IMPORTANT SAFETY RECALL
NHTSA Recall# 20V-551

Subject: Safety Tethers on units with Flat Bottom Floors

No.: B20012

Re.: Inspection and Repair of Safety Tethers
on units with Flat Bottom Floors

Tether Bolt Present

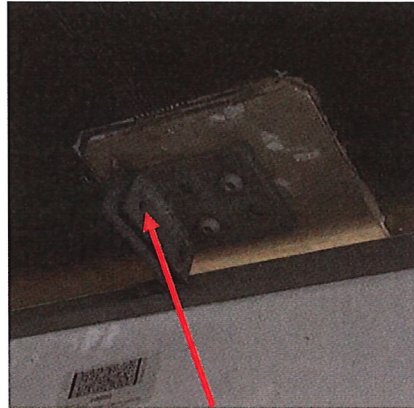
Inspection: An immediate inspection should be completed on all affected units to confirm that the bolts securing the two piece Safety Tether are present and secure. If these bolts are **not** present the unit should be taken out of service until the bolts have been replaced, or the instruction in this bulletin can be completed. It is preferred that this recall be completed in conjunction with campaign bulletin B20008 to reduce unit downtime. If the bolts are present the unit can remain in service, but it is recommended that the steps in this bulletin be completed as soon as practical.

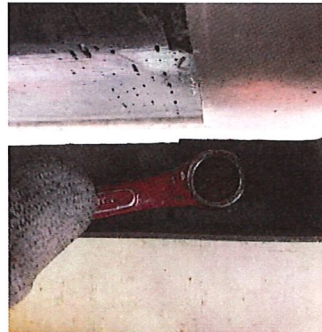
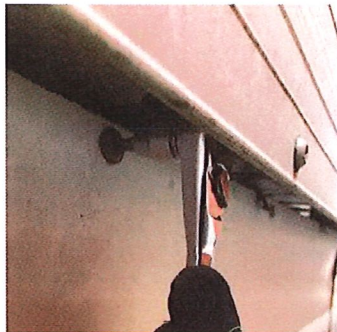
1. Remove the bolt and nut securing the Tether bracket to Skirt panel.

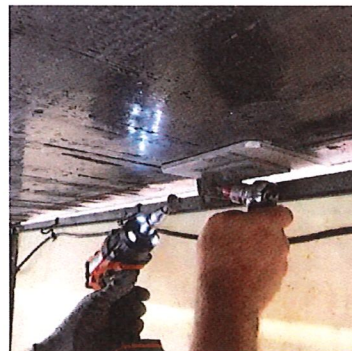
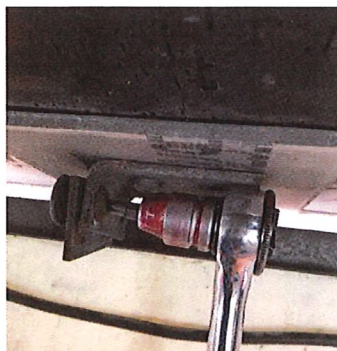
2. Remove the bolt and Tubular nut connecting the two pieces of the Tether assembly.

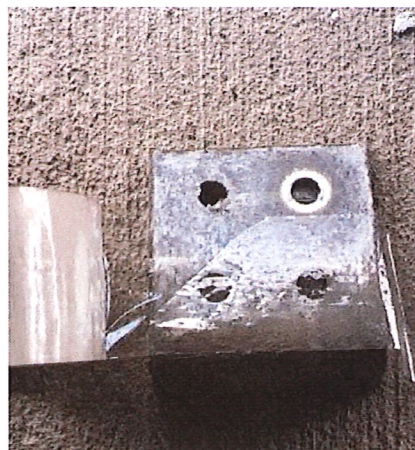
3. Remove the two bolts securing the Angle bracket portion of the Tether assembly to the bottom of the Flat floor. **Note:** It is not uncommon for these bolts to break during removal.

4. If one or both bolts break during removal, locate and mark the holes in the opposite diagonal mounting locations, and drill out for reassembly using a 9/32" Drill bit.

5. Apply Mylar tape to the mating surface of the Angle bracket portion of the Tether assembly.

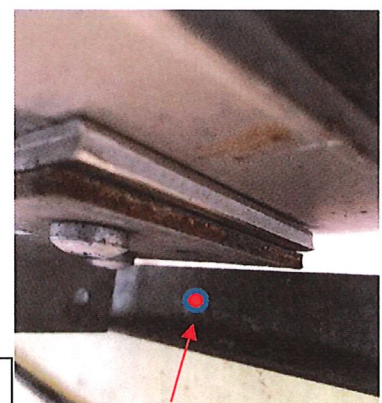
6. Position the provided ¼" Aluminum shim between the Angle bracket and the Aluminum plate on the bottom of the Flat floor.

7. Using bolt part number BLT00155 insert the bolts and tighten.

8. Rotate the secondary piece of the Tether assembly 180 degrees, locate for proper position, and mark for drilling new mounting hole.

Note: After rotating this portion of the assembly 180 degrees, the offset section should be pointing down vs. up as in its original location. This is to gain adequate clearance for the Free Floating assembly.

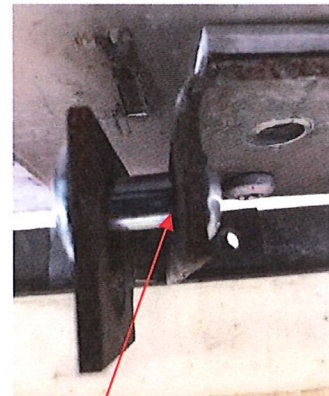
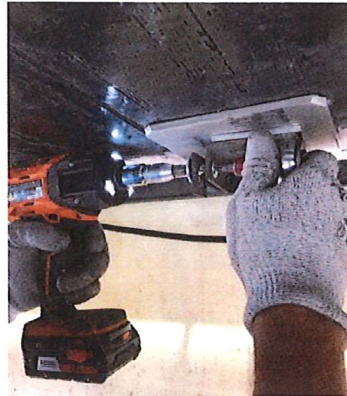
9. Install the new Tether bolt and nut. When tightening be sure that there is no gap between the Tubular nut, and the mating surface of Tether Angle bracket.

No Gap Here

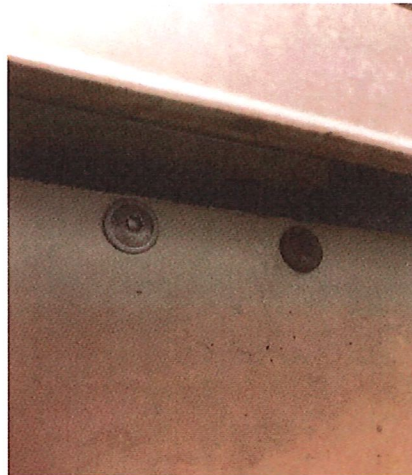
10. Finalize the repair by resecuring the Tether bracket to the Aerodynamic panel using the new provided bolt and nut, and fill the pre-existing hole with the original bolt and nut. Repeat these steps on all six Safety Tether assemblies. **Note:** It may be required to remove the front most panel on the roadside of the unit to gain full access to the Tether assembly in the area of Fuel tank.
